INTEGRATED SILICON SOLUTION, INC.

Product Change Notification

Change Notification No. 20171023-1

Effective from Dec 1, 2017, the carrier tape for the package WSON 5x6, will be changed to the attached new specification. Order placed to ISSI after the effective date will be shipped with the new carrier tape. Orders placed to ISSI before the effective date will be shipped with the old carrier tape together with a SPA# U1322A to identify the old tape is used.

Old Carrier Tape for WSON 5x6mm Package (SPA# U1322A)

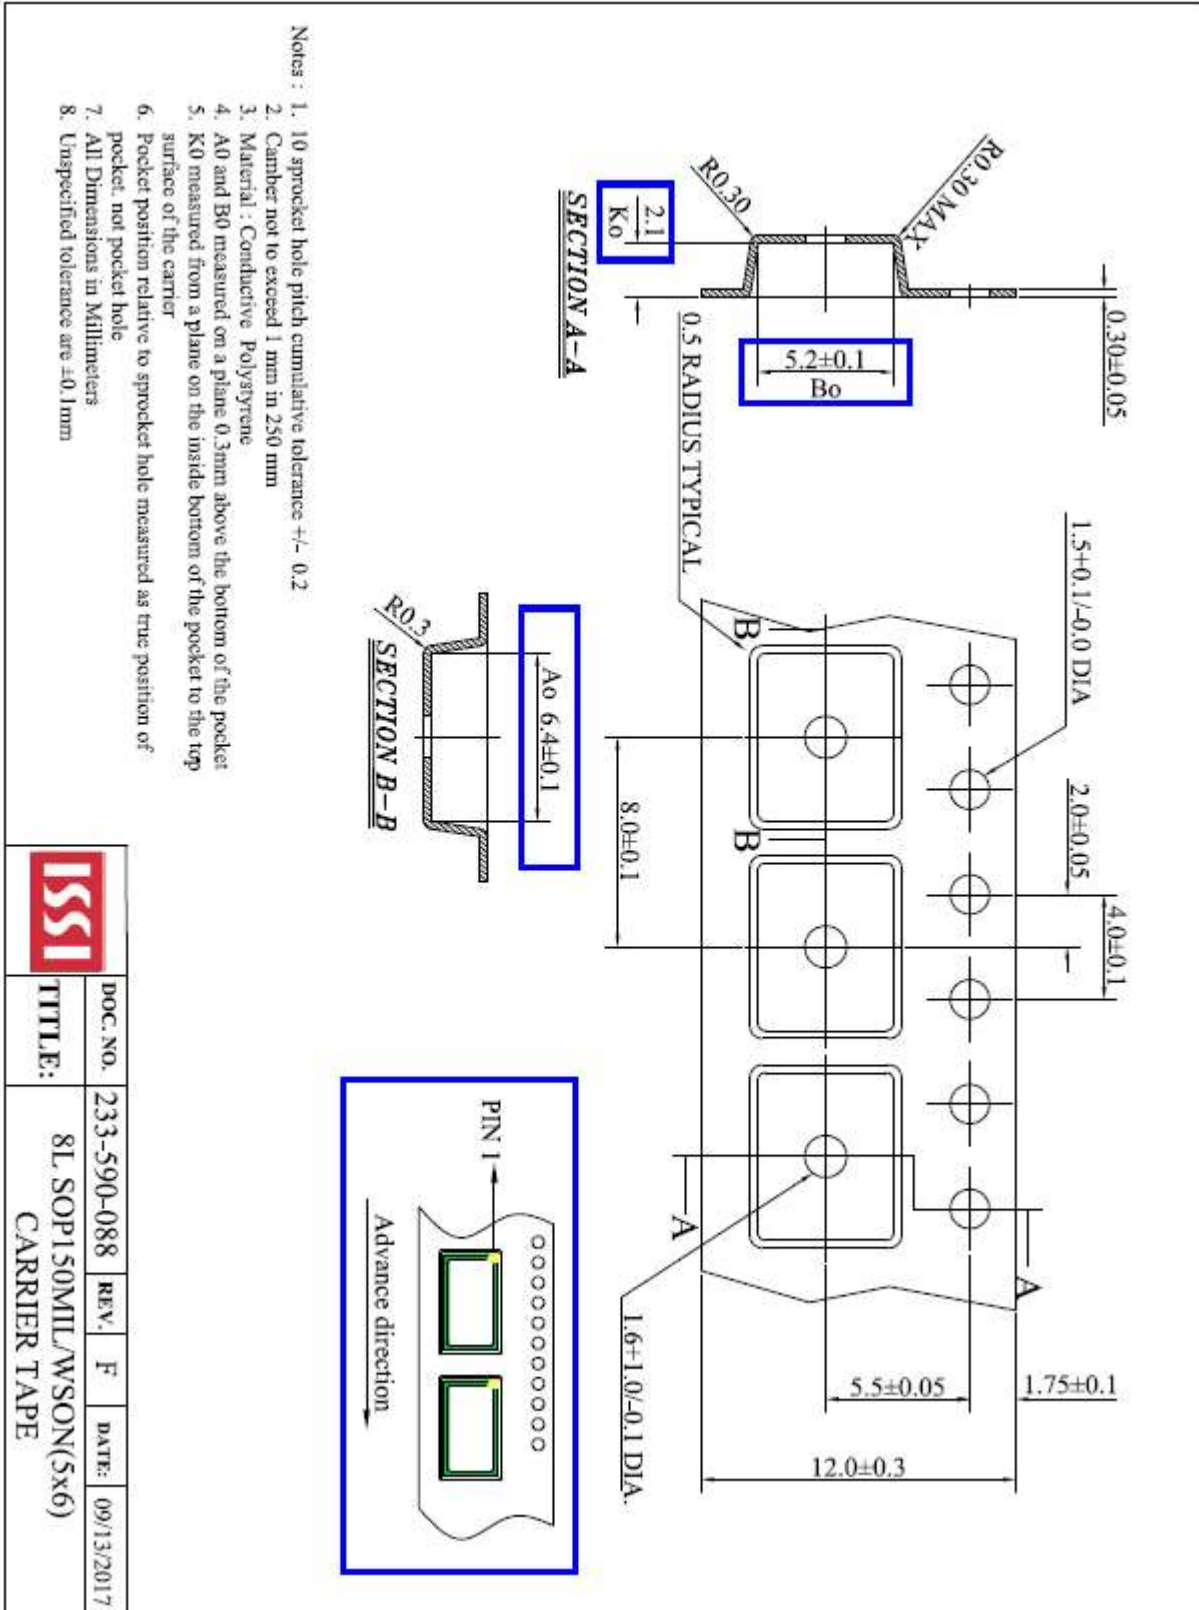
Item	Old (SPA:U1322A)	New
A0 dimension	6.4±0.1	5.3±0.1
B0 dimension	5.2±0.1	6.3±0.1
K0 dimension	2.1±0.1	1.25±0.15
Pin orientation	upper-left	upper-right
Q'ty /per reel	3,000ea	4,500ea

The new carrier tape specification aligns with Industry standards for WSON 6x5mm.
